PCN#: PCN_EMCSA-Stepcode_DE-PCN-20192208
 Change Title: New energy store and transport mode for EMCSA
 Date of publication: September 2019

- EMCSA / S3001-C320 (Stepcode DE and later)

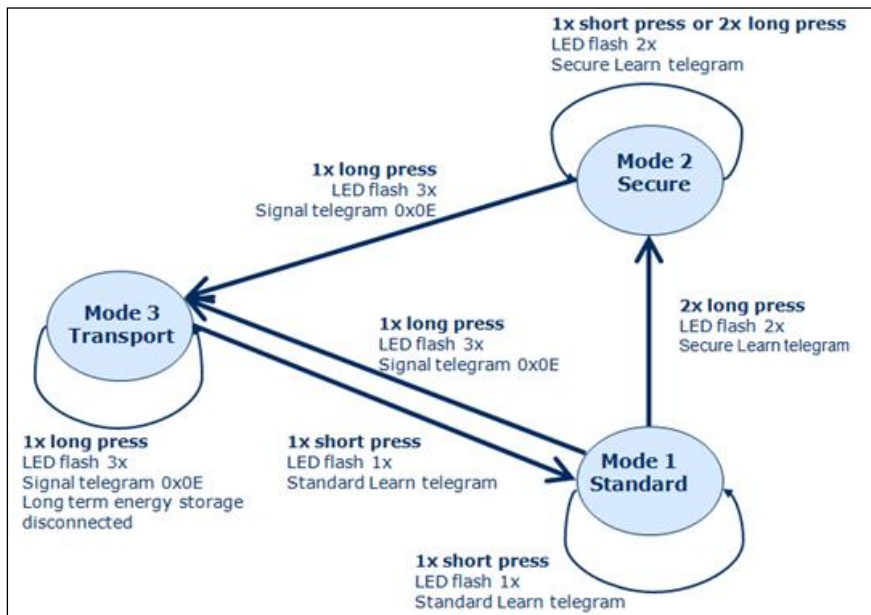
- **Product label and documentation:** Self-created OEM product labels and/ or user documentation have to be updated to reflect the new feature set and consider additional regulatory requirements
- **Waste Treatment, additional regulatory requirement:** A registration according to Battery Directive has been already done for Germany. Since the European Union requires country specific recycling, for all other countries than Germany the OEM customer (B2B) has to register at country specific recycling organizations.
- **Storage:** OEMs might consider putting the final product to transport / storage mode based on their logistic chain
